SMYRNA MUNICIPAL PLANNING COMMISSION

February 1, 2024
5:00 p.m. meeting

SMYRNA MUNICIPAL PLANNING COMMISSION

MEETING MINUTES JANUARY 4, 2024

1. Addition to Villages of Valley Green, Section IV - **Request to be deferred**
 Enon Springs Road W & Wildwood Drive
 Owner / Developer: JSD Holdings

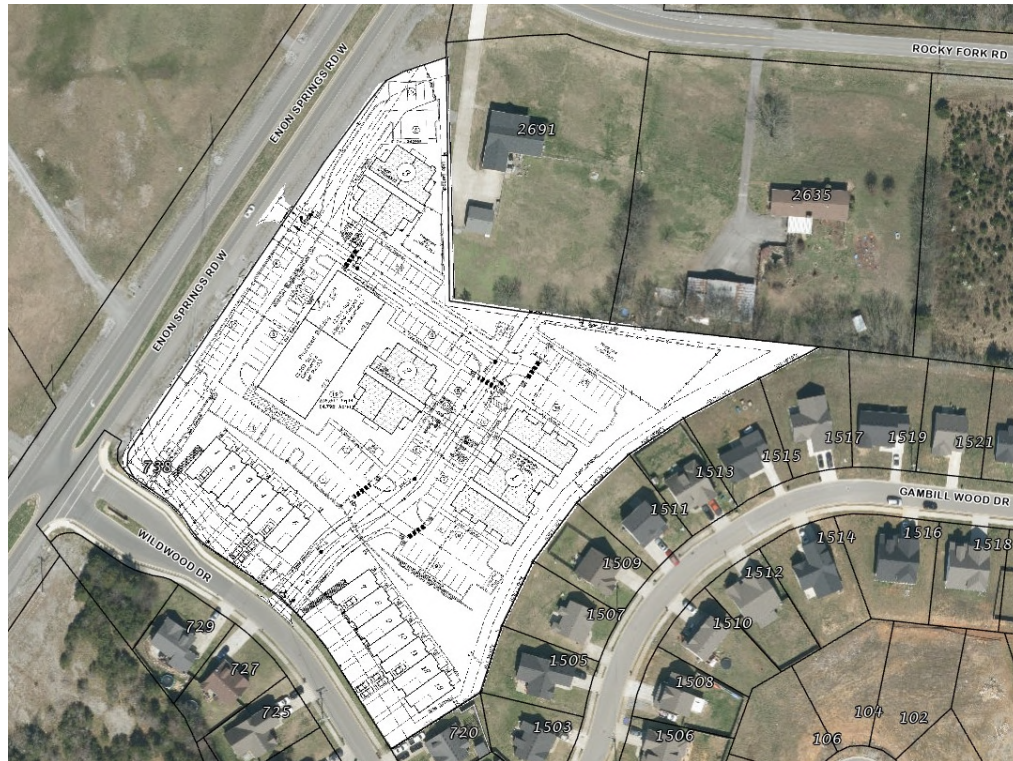
1. Construction plans are under review.
2. Landscaping along Enon Springs Road, West will be required to comply with MTEMC overhead utility requirements.

3. Provide the square footage of the townhomes in order to calculate the correct required fire flow. Depending on the proposed square footage, buildings may be required to be sprinkled.

4. Staff would recommend that the privacy fence be constructed of a different product than wood for durability purposes.
5. Ensure the sidewalk corners meet ADA requirements.

6. Ensure the storm system intercepts flow from impervious surfaces on site and are directed to the pond.
7. Ensure all storm structures are located in a clearly marked drainage easement or common area.

8. Drainage structures and landscape buffers must not overlap.
9. Extend sewer to the Walter Gambill property.
10. Any balcony or covered area must meet minimum building setbacks.

11. Show an example of the playground equipment to be used in playground areas.
12. This site is part of a PUD which was approved several years ago which allowed for 60 multifamily units. There were no specifics within the PUD as to the type of multifamily units. The required parking at the time of PUD approval for all multifamily units was 2 spaces per unit. Since that time, the Town has amended the parking requirements for townhome developments to 4 spaces per unit plus .5 space per unit for guest parking. This translates to 270 parking spaces which would be required for this development. As shown, 13 units have 4 driveway spaces, 23 units have 2 driveway spaces, and 24 units have 1 driveway space. In addition, there are 40 surface parking spaces. This totals 162 spaces. The site as proposed does not meet current parking requirements for townhomes. The required parking for apartments remains 2 spaces per unit.

1. Legends of Smyrna, Lot 4A
Almaville Road
Owner / Developer: Fleeman Living Trust / Greg Patel

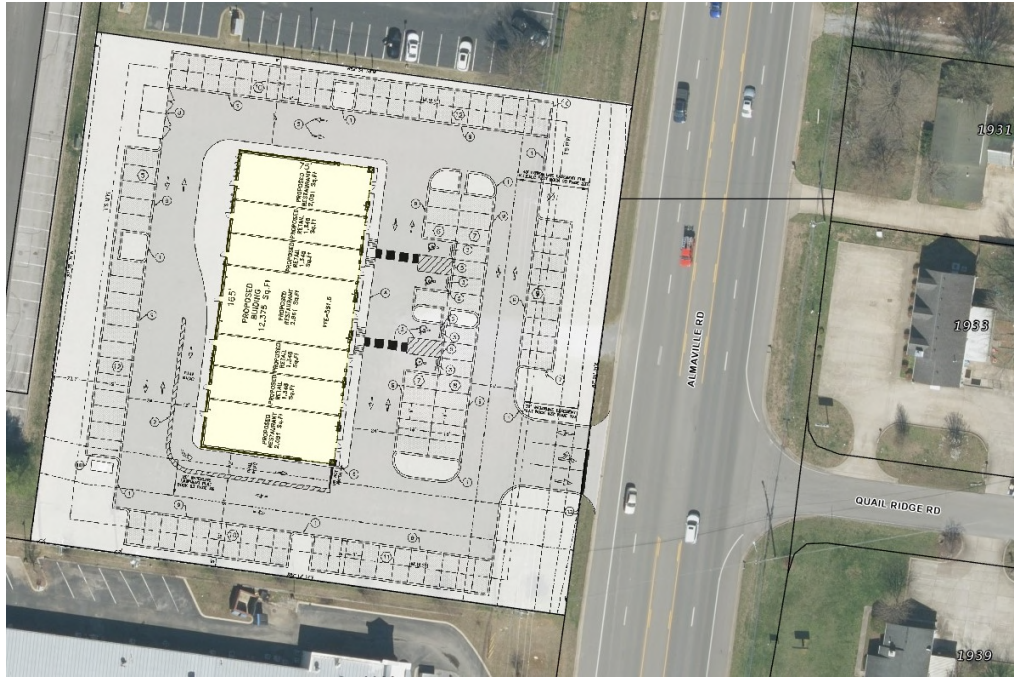
1. As submitted, the required minimum fire flow is 1,500 GPM at 20 PSI.
2. It appears that the dumpster enclosure is set up for two dumpsters for potentially seven businesses including potentially three restaurants. If this proves to be inadequate and additional dumpsters are needed in the future, the enclosure will have to be rebuilt to enclose all needed

- dumpsters.
3. Expand the dumpster enclosure to include a 3rd dumpster.
 4. Provide TDOT approval for driveway entrance off of Almaville Road prior to issuance of a building permit.

5. There is a possibility that in the future the center turn lane of Almaville Road may be removed. At that time, the access to this site would become a right in/out only.

6. Adequate parking is shown to meet the Zoning Ordinance. However, the area of the building which is able to be used as a restaurant is limited to 7,000 square feet in order to maintain adequate parking for the site.

7. The proposed plan for stormwater detention exclusively utilizing pervious pavers will be reviewed with the grading permit.
 8. CUD's existing infrastructure should be adequate to meet the 1,000-1,500 GPM fire flow requirement for this site.

9. Consolidated Utility District of Rutherford County (CUDRC) has an existing ten (10) inch water main along the southern property line and a twelve (12) inch water main along Almaville Road.

10. Submit a water service availability request to CUDengineering@ cudrc.com for feasibility study and to receive a Will Serve letter from CUD.
 11. Submit a full set of plans directly to CUDengineering@ cudrc.com for further review and comment.

Addition to Village of Valley Green

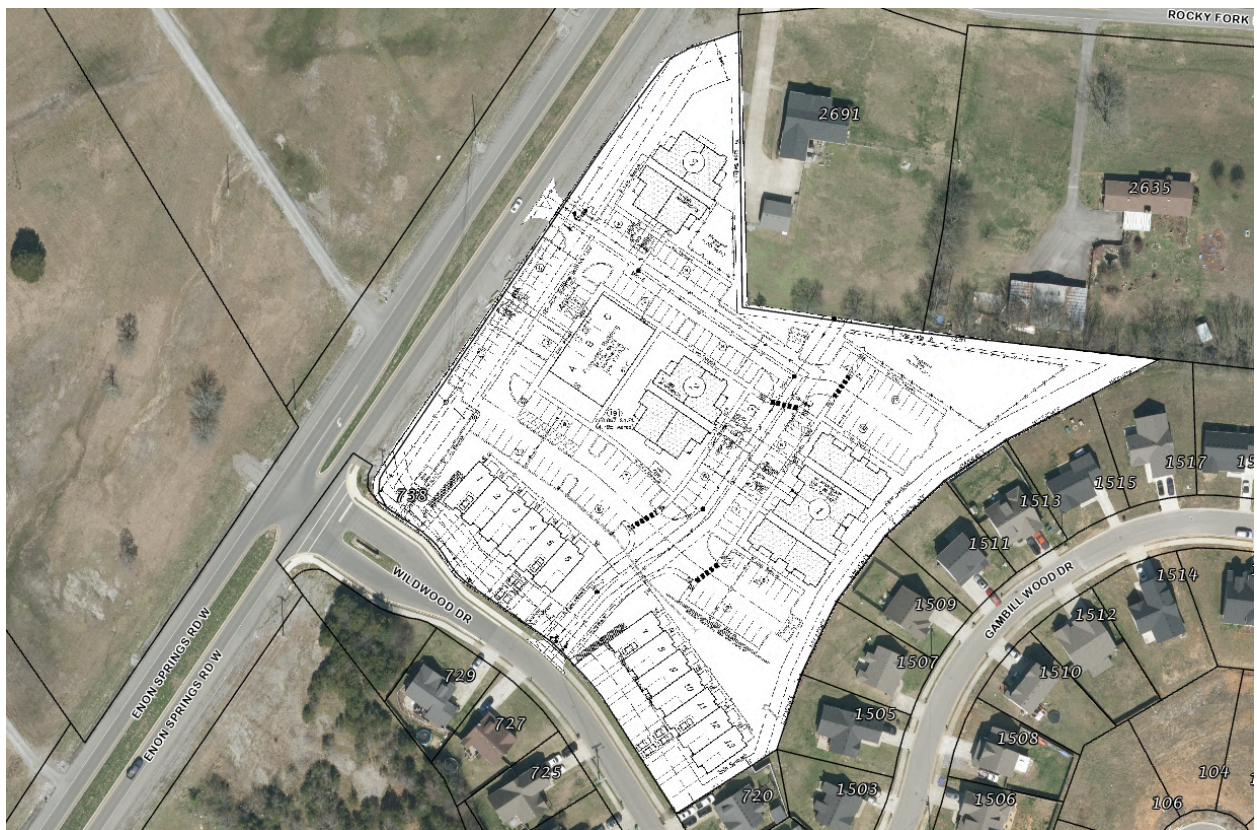
1. Utility plans are under review.
2. The required minimum fire flow will be 2,125 GPM at 20 PSI. This is based on the largest apartment building. The apartments are required to be sprinkled, and the other buildings may be required to be sprinkled depending on the construction type and available fire flow.

4. Please show on the plans whether the townhomes will be a for sale product or rental. This affects how the units are provided sewer. If they are to be a for sale product, the sewer lines in the rear of townhomes must be a public sewer main. Show the required easements.

5. Landscaping along Enon Springs Road, West will be required to comply with MTEMC overhead utility requirements.
6. Landscaping and storm structures cannot overlap. Please show one or the other relocated as needed.

12. Sewer main required to be extended to the Gambill property.
13. Provide architectural elevations for all buildings on the property including townhomes, apartments and the commercial building showing all four sides, the material percentages per wall face, and the material percentages for the overall building.

14. The elevations on the commercial building appear to show a block for the base of the building while materials label it as brick. Please verify.
15. Please show additional dumpsters for the development. Provide dedicated trash receptacles for the commercial building.

16. The auto-turn appears to show the truck entering parking spaces. This is not allowed. Please resubmit the auto-turn with any necessary changes to eliminate this issue.

18. Please show a loading/unloading zone for the commercial building which does not interfere with the auto-turn.
19. Provide a Type C landscape buffer between the multifamily uses and all of the surrounding single family uses.

20. Please provide additional vegetation between apartment building 2 and the commercial building similar to a Type C landscape buffer.
21. The parking calculations in the site data table are incorrect. Please adjust accordingly.

22. This site is required to meet ADA requirements. Based on the number of parking spaces provided, a minimum of 6 handicapped parking spaces are required. At least one of these spaces must be van accessible. Please show handicapped parkings spaces spread throughout the development to serve all the apartment buildings as well as the commercial building. Handicapped people should not be required to cross drive aisles to reach their destination.

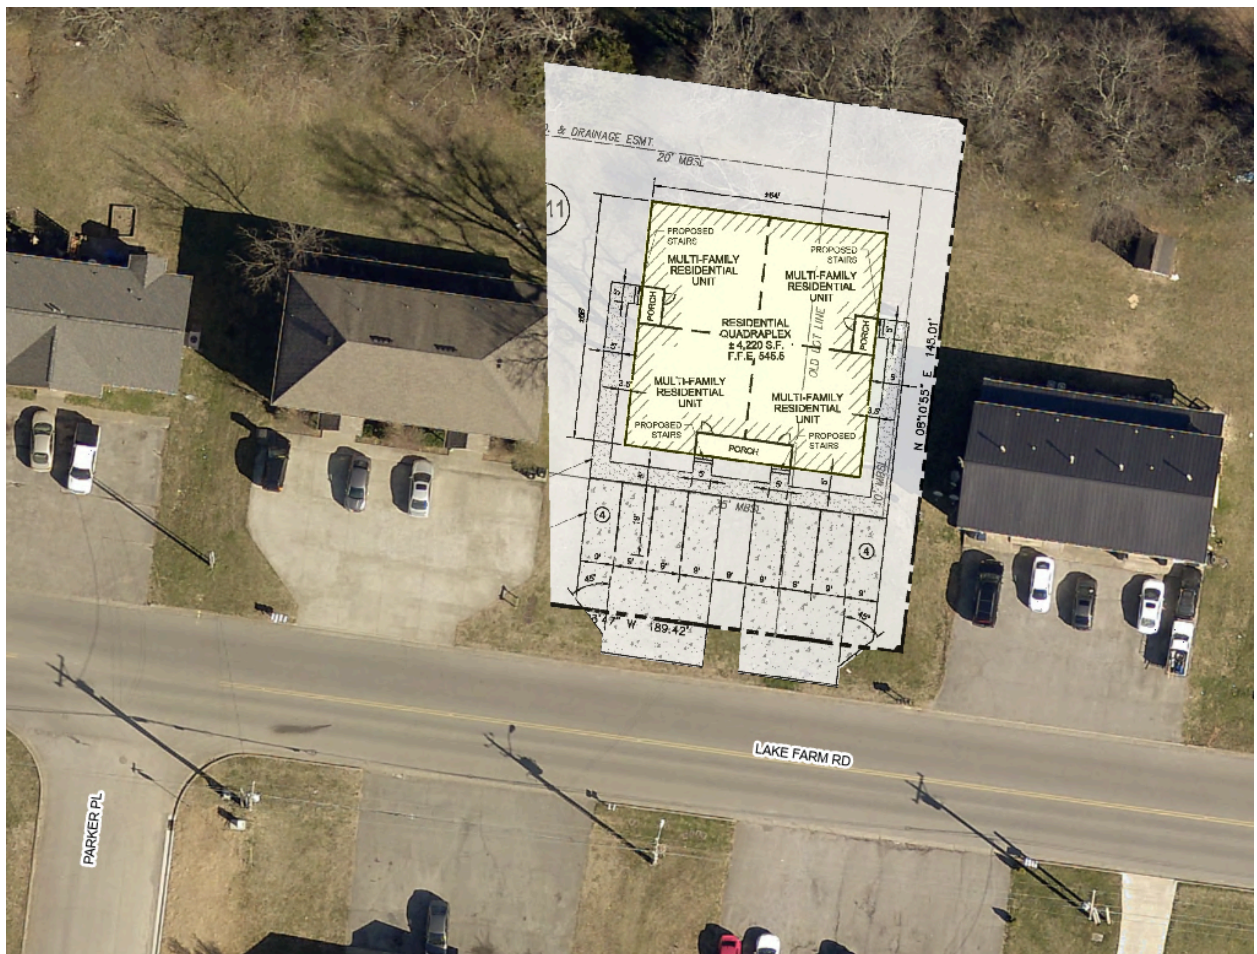
1. The site will be required to comply with ADA requirements due to the development being a quadruplex and is required to meet the commercial Building Code. One unit must be ADA compliant, a van accessible handicapped parking space is required, and a ramp is required.
2. The Zoning Ordinance requires 4 parking spaces per unit based on a quadruplex. Eight parking spaces are currently shown. An additional 8 spaces are required.
3. All water services lines must have a 2" gate valve by the utility main at the building to the left.
4. Show details for landscaping to be used in a data table.
5. Please update the FEMA map information to the current map.

Planning Commission
Advance Auto Parts
2-1-2024

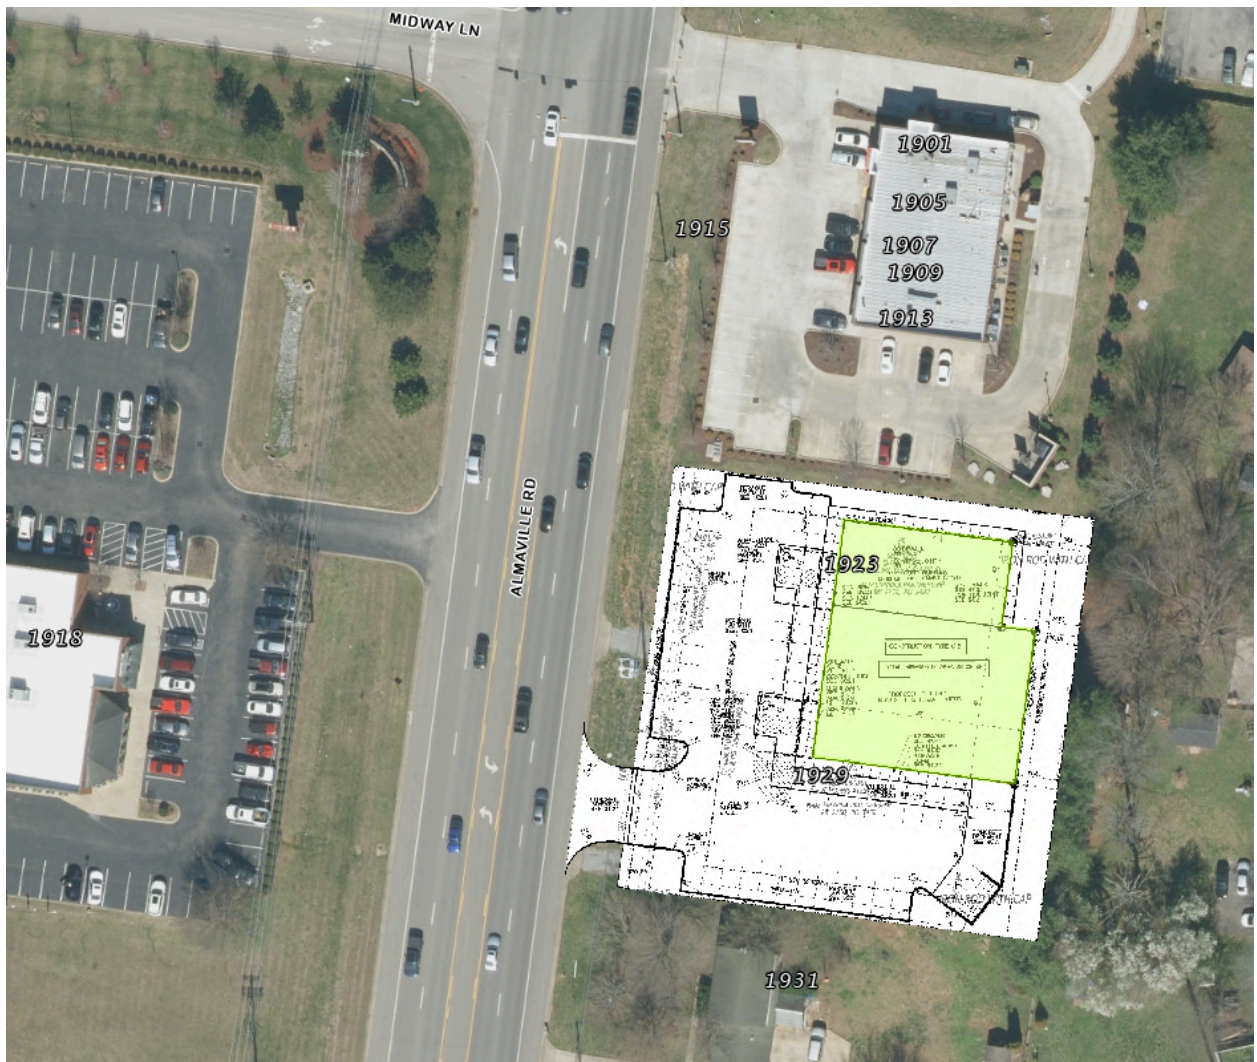
2. Rooftop HVAC units are shown extending above the proposed parapet wall to be visible from the road. Please increase the parapet wall to completely conceal the units from the ROW. A sight distance study from motorists viewpoint on Almaville Road would verify if the HVAC units are concealed.

3. What type of sprinkler system would be used?
4. Show a sewer cleanout a maximum of 10' from the main.
5. The FDC must be 30' off the building and 100' from fire hydrants.

6. Coordinate landscaping requirements with MTEMC for the overhead utilities along Almaville Road.
7. Landscaping square footage does not meet the minimum required amount. Please add additional landscaping.

11. Submit updated full set of plans directly to CUDengineering@ cudrc.com for further review and comment.
